Warranty Bulletin**95-25**Date: **June 1995**Section: **22**Subject: **A/C BELT TENSIONNER PULLEY - CENTRAL A/C SYSTEM**

FIGURE 2: ENGINE AND COMPRESSOR

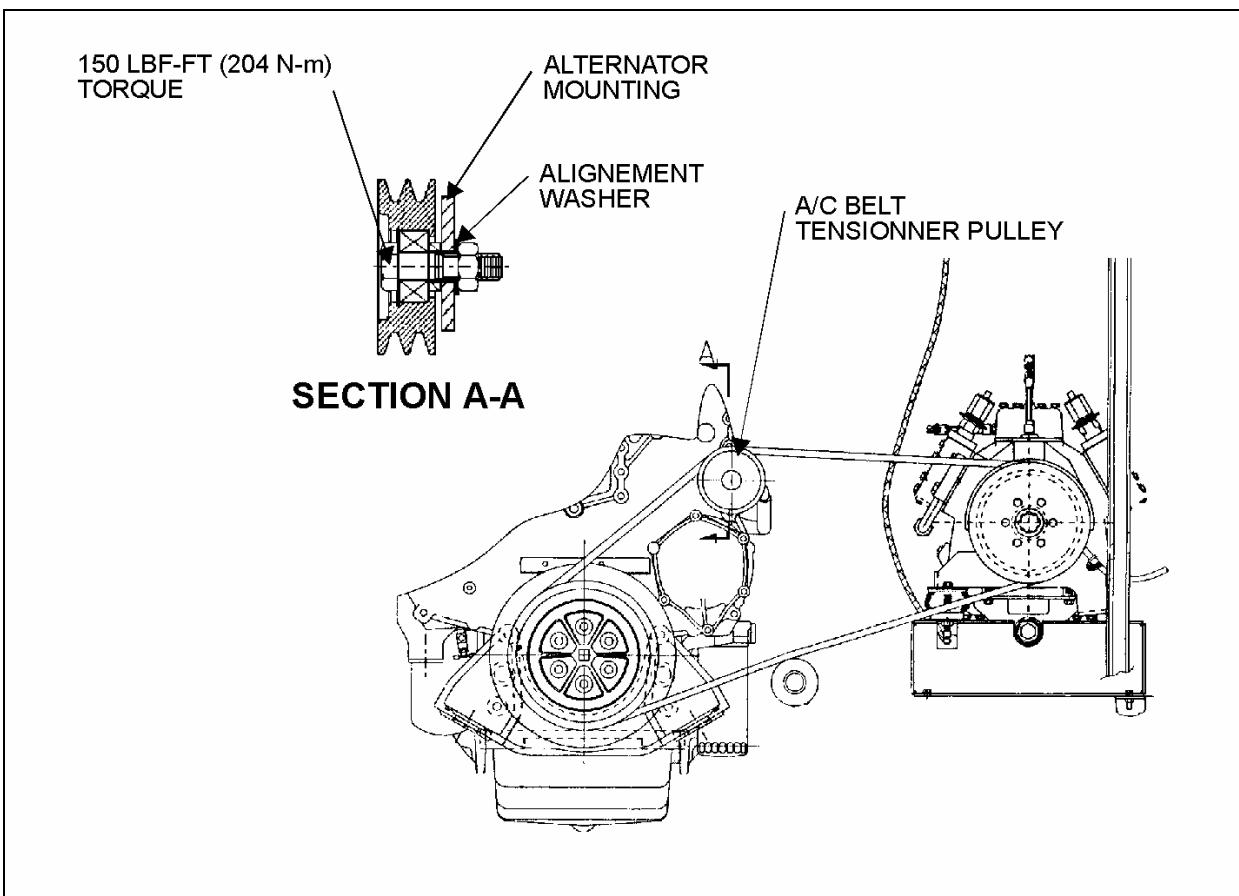
On some of the above-mentioned vehicles, it is possible that a bolt on A/C belt tensioner pulley does not have a good torque. Therefore, you should make the modification described in the following procedure.

3. Remove nut from belt tensioner pulley bolt (Fig. 2).
4. If applicable, remove old alignment washer (Fig. 2).
5. Install a new alignment washer (Prevost number 452276) (Fig. 2).
6. Install nut and torque belt tensioner pulley bolt to 150 lbf-ft (204 N-m) (Fig. 2).
7. Set battery master switch(es) to the ON position.
8. Apply pressure to air bellows by means of belt tensioning pressure control valve.
